Part: SE141-115 / MODULAR COIL, TYPE B

Drawing ID: SE141-102 Revision: 3
W/O Links: 1-Type:W: 65708/3.0 Sub: 0

Problem: SEVERAL ITEMS NOTED DURING VISUAL REVIEW OF CASTING. SEE ATTACHMENT.
Rev. 1 - added pages 9 & 10 to the attachment. (1-2-07)

NC20920 – B3 Visual Review

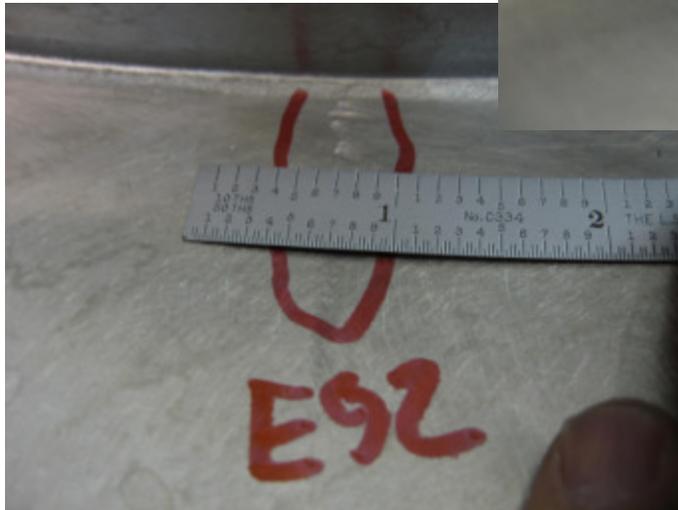
Tool Gouges on E side Long Leg near radius

Tool Gouges on E side Long Leg near radius

.400" distance from short leg to VPI groove (sheet 2, zone G7)

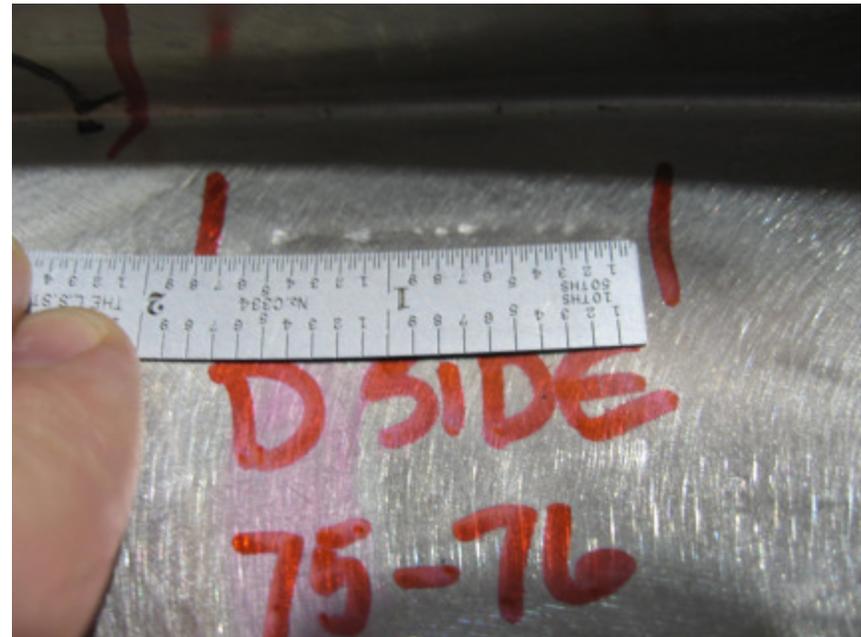
There is an area on the Datum D side from T hole 81 to 86 that checks as small as .300".
The transition has been blended smooth.

There is an area on the Datum D side from T hole 70 to 73 that checks as large as .506".

Tool Gouges on D side Long Leg near radius

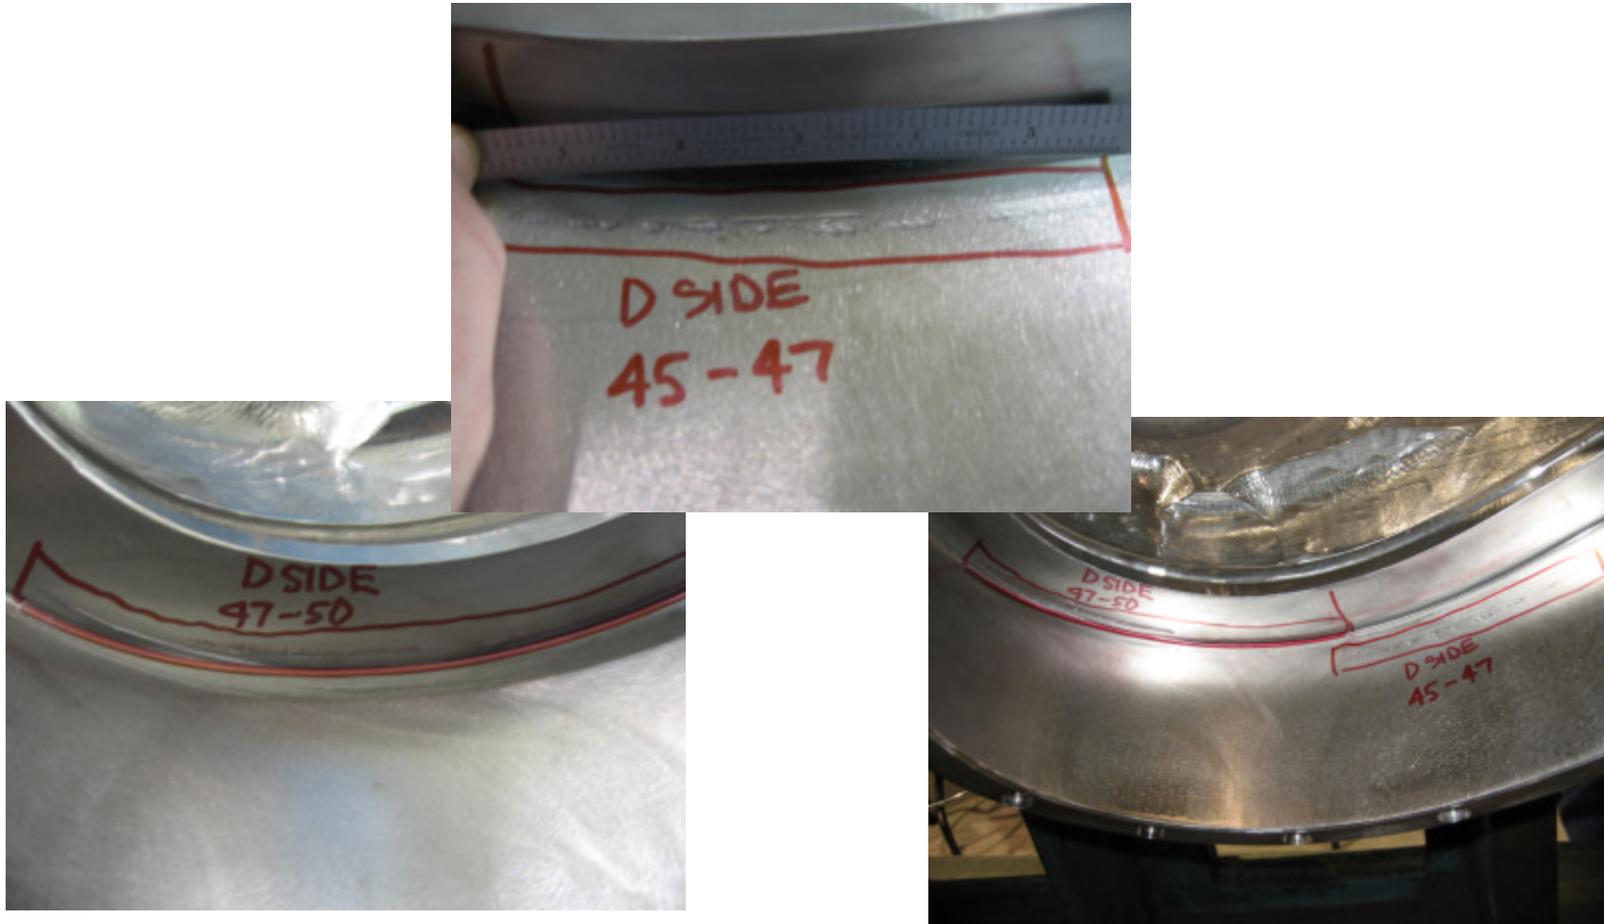
Tool Gouges on D side Long and Short Legs near radius

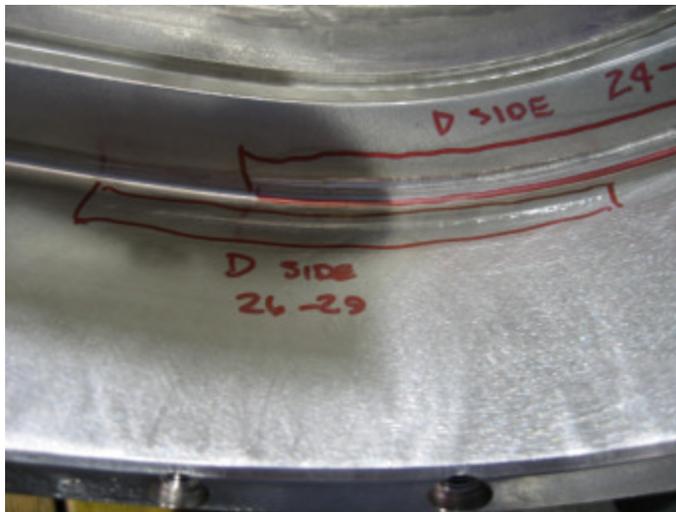
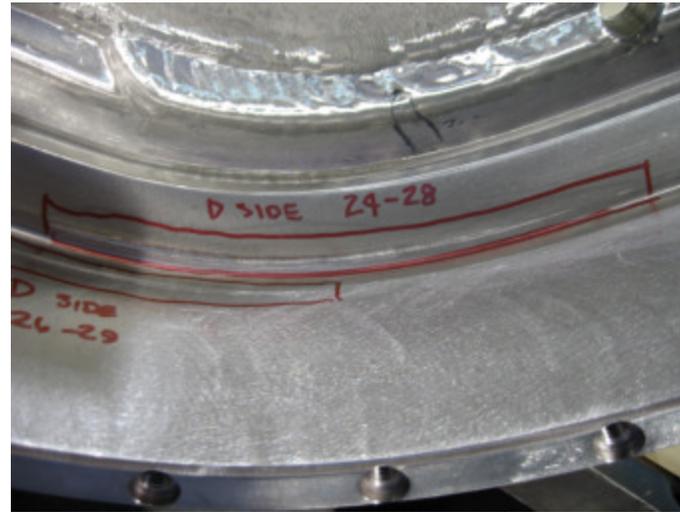
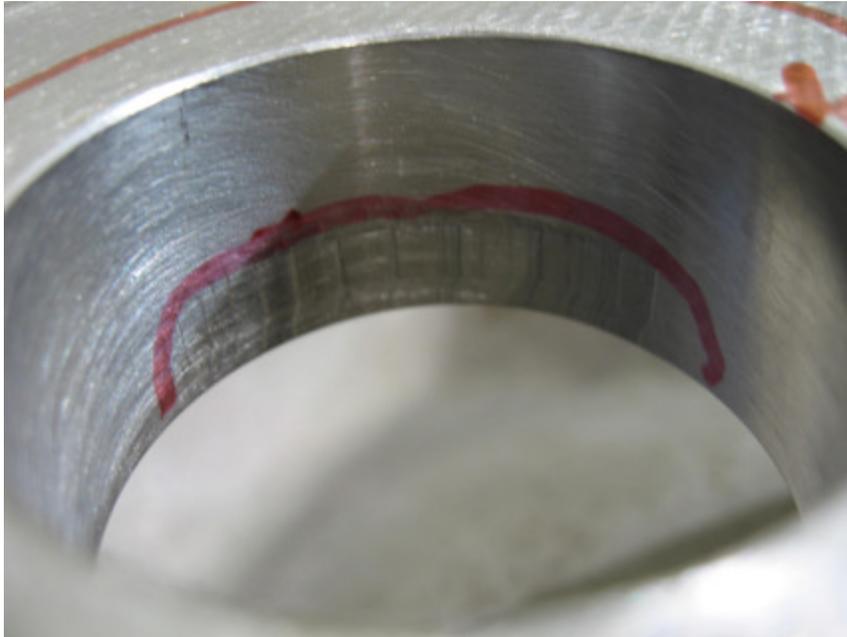
Tool Gouges on D side Long and Short Legs near radius

Oversize area in hole #27 in Datum E flange. (reported on NC20917 step 730)

Undercut areas adjacent to .12" radius of Long Leg

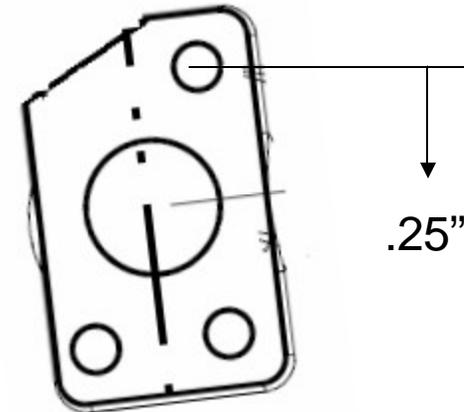
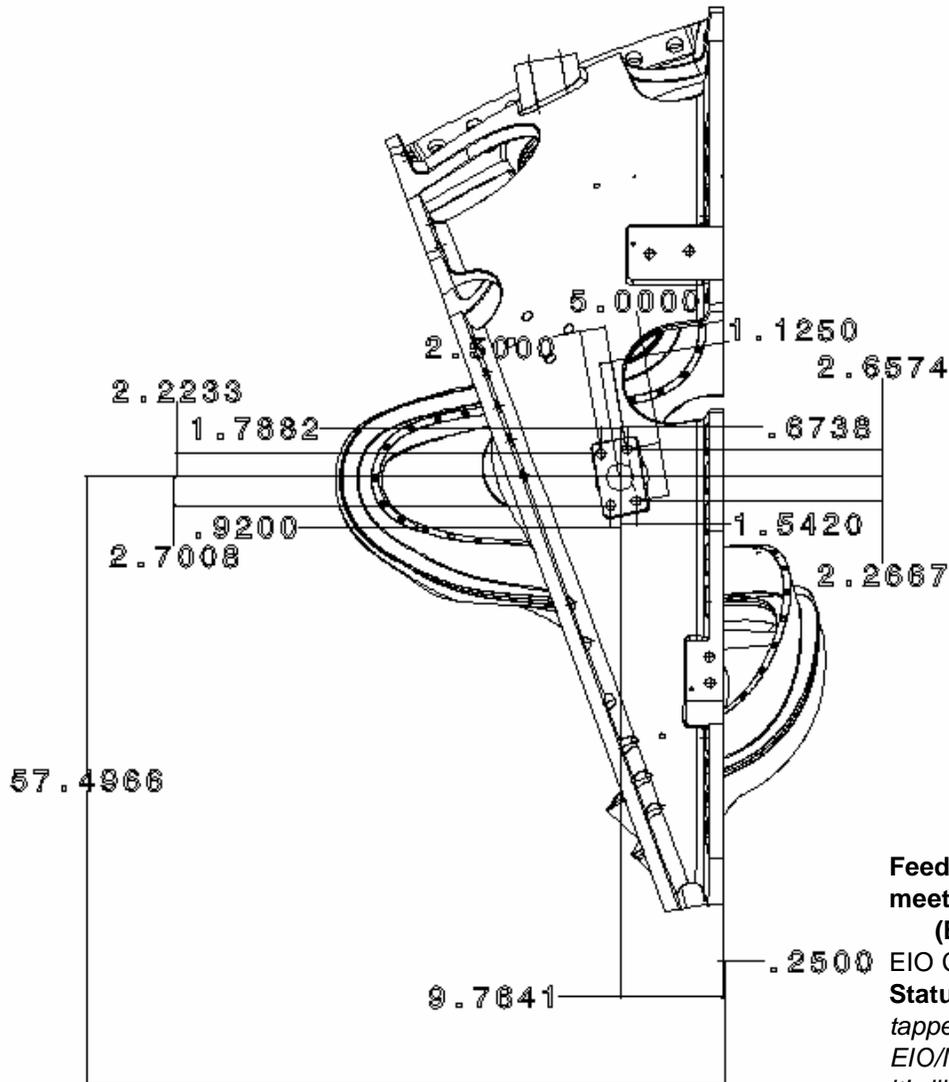
The picture to the left is of the port opening on the Datum D flange just beneath the Lead Block pad.

A programming error resulted in too much material being removed during the rough machining operation. An area on both sides of the port did not clean up.

One area measures approximately .25" x .25" and the other is .35" x .35". Both cutter marks extend through the opening the thickness of the casting wall.

From the orientation shown, the 1-8" hole pattern was shifted .25" down. This hole pattern, per the model, was not centered about the 2.5" hole prior to this shift.

(EIO, MTM) Provide documentation of completion of corrective action for EIO CA 090606(NCR) for B-3 & B-6 Vacuum Vessel support pads deviations.
Status: (Open) MTM confirms that the center hole position is fixed but the tapped hole pattern is being shifted as needed (applies to all Type B castings). EIO/MTM will provide proposed shifted locations prior to drilling. On B3 & B6 it's likely that one hole cannot be drilled (corner missing). The CA will remain open until after B6 is completed.
